Amherst Island Wind Energy Project - Renewable Energy Approval Amendment Modification Report #4

File No. 160960595 May 2015

1.2 SUMMARY AND RATIONALE FOR MINOR MODIFICATIONS

1.0 DRAFT	
Project Location - Modification	on #3:
Overview

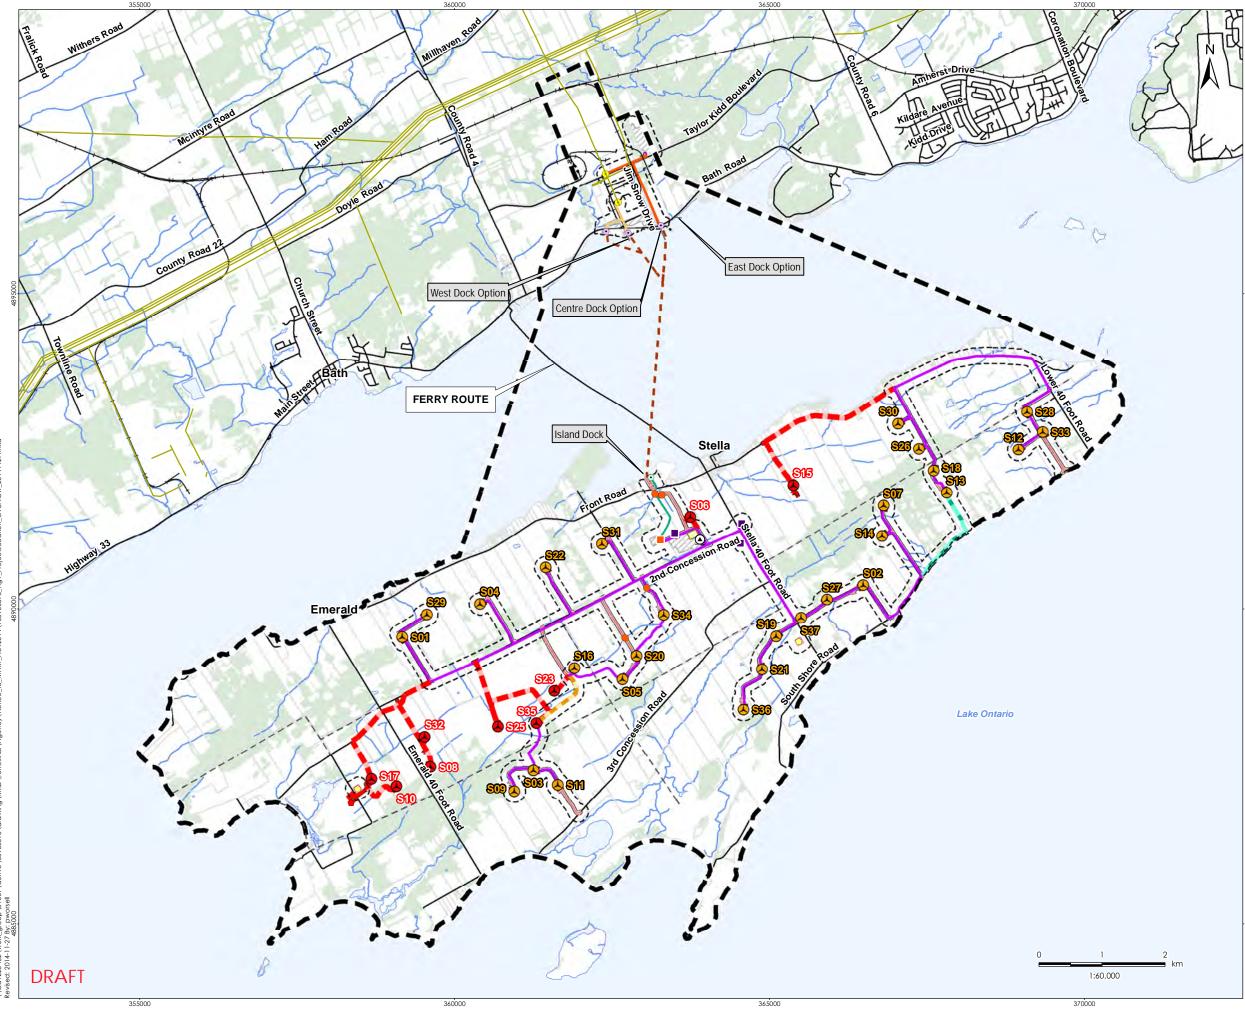
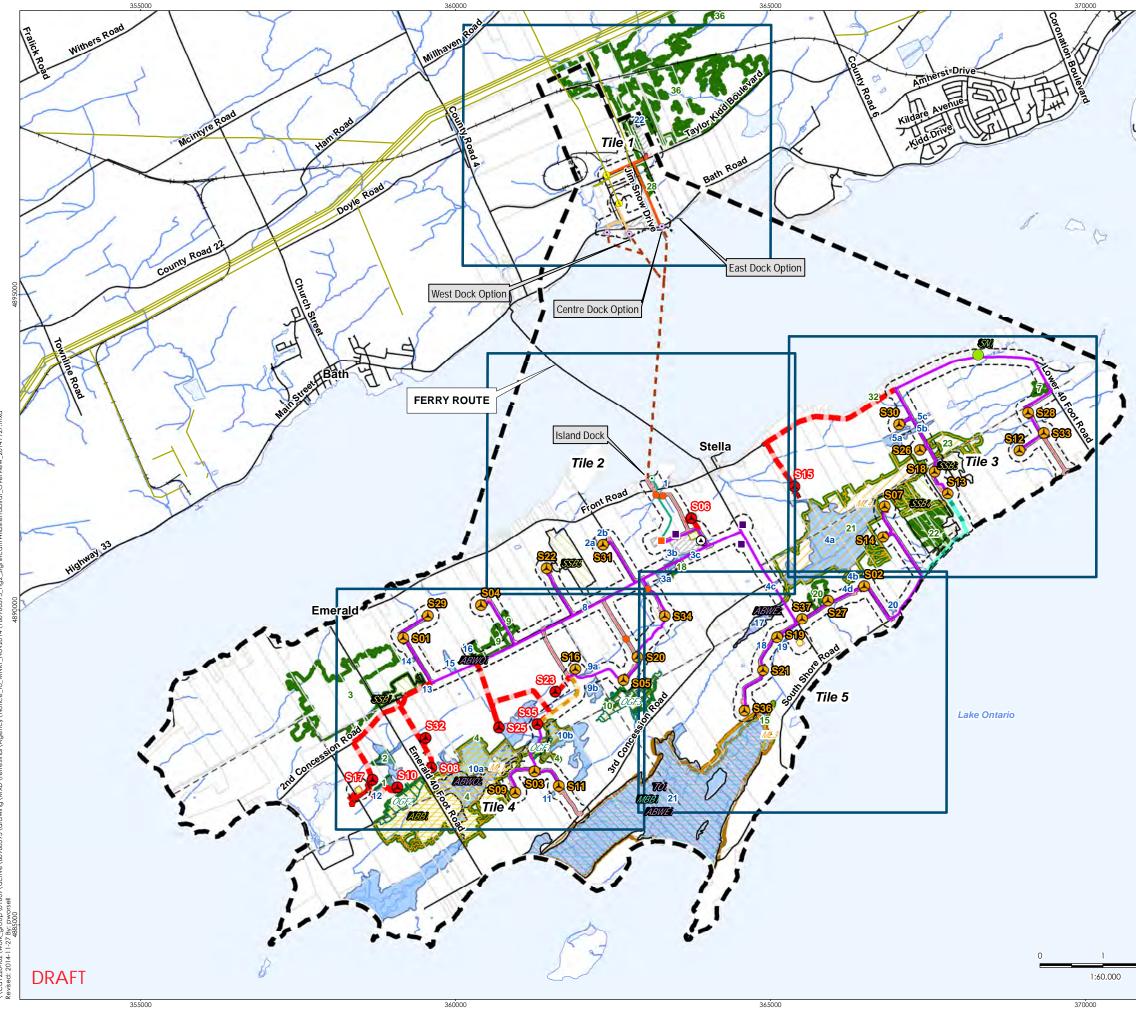
- The reduction in the number of Wind Turbines by changing the Turbine Model (12 2.942 MW turbines and 15 2.772 MW turbines) (see **Figure 1**, **Attachment 1**); and,
- The addition of an underground collector line along a previously approved access road between T16/T23 and T35 (see Figure 1, Attachment 1).

- The location of an underground collector line along South Shore Road and up to \$13 (see Figure 1, Attachment 1).
- Removal of the portions of the proposed underground collector line along Stella 40 Foot Road and Front Road.

The Project modification involves the addition of an underground collector line along South Shore Road within the road right-of-way and on private land from the access road for \$14 to \$13. The modification would include removing portions of the underground collector line along Stella 40 Foot Road and Front Road (**Figure 1, Attachment 1**).

Project Location & Study Area: Proposed Modifications

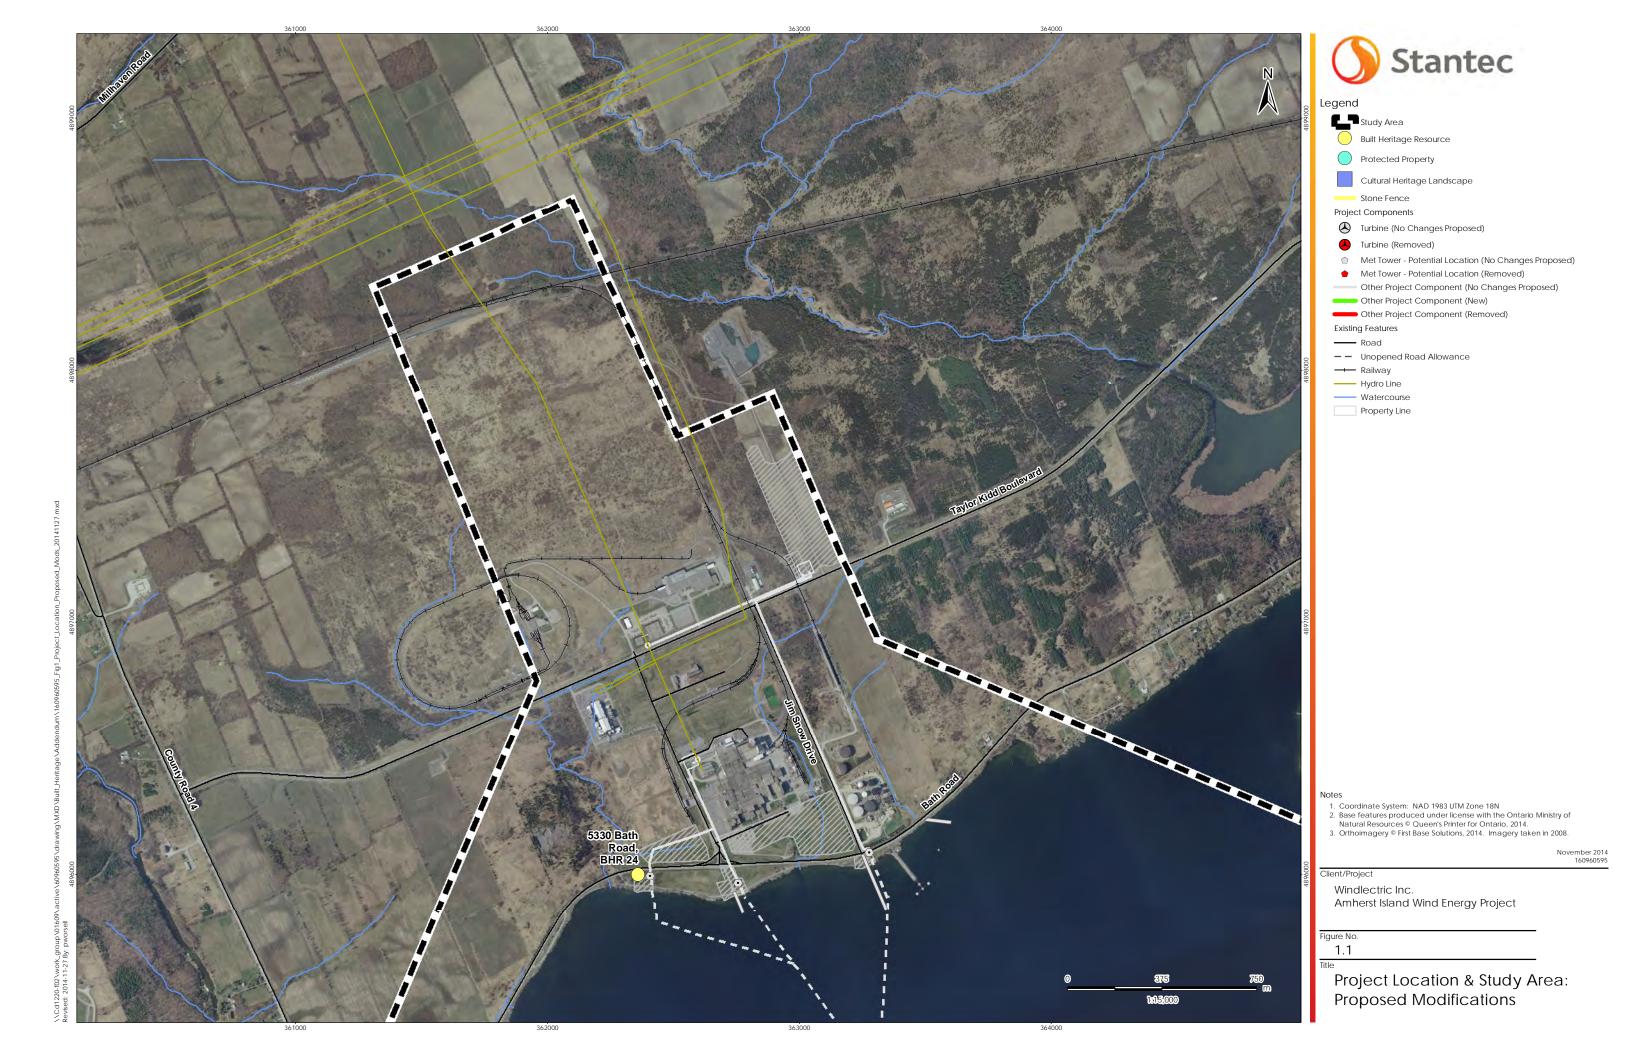
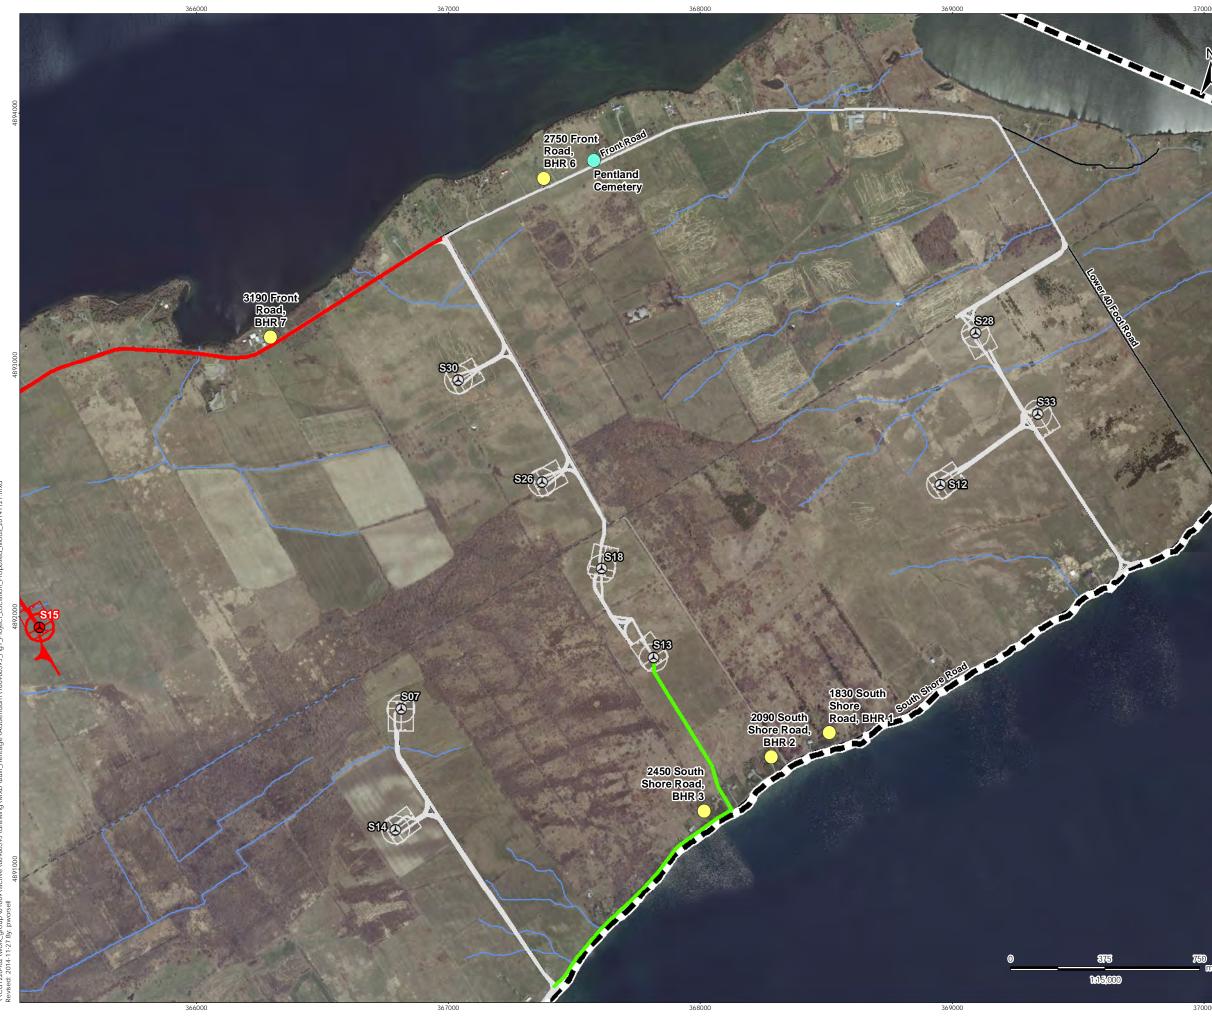
- a) The reduction in the number of Wind Turbines by changing the Turbine Model (Siemens 2.942 MW and 2.772 MW) (see **Figure 1A, Attachment 1**);
- b) The addition of an underground collector line along a previously approved access road between T16/T23 and T35 (see Figure 1A, Attachment 1); and
- c) The addition of an underground collector line along South Shore Road and up to \$13 (see Figure 1, Attachment 1). Along with the removal of the portions of the proposed underground collector line along Stella 40 Foot Road and Front Road.
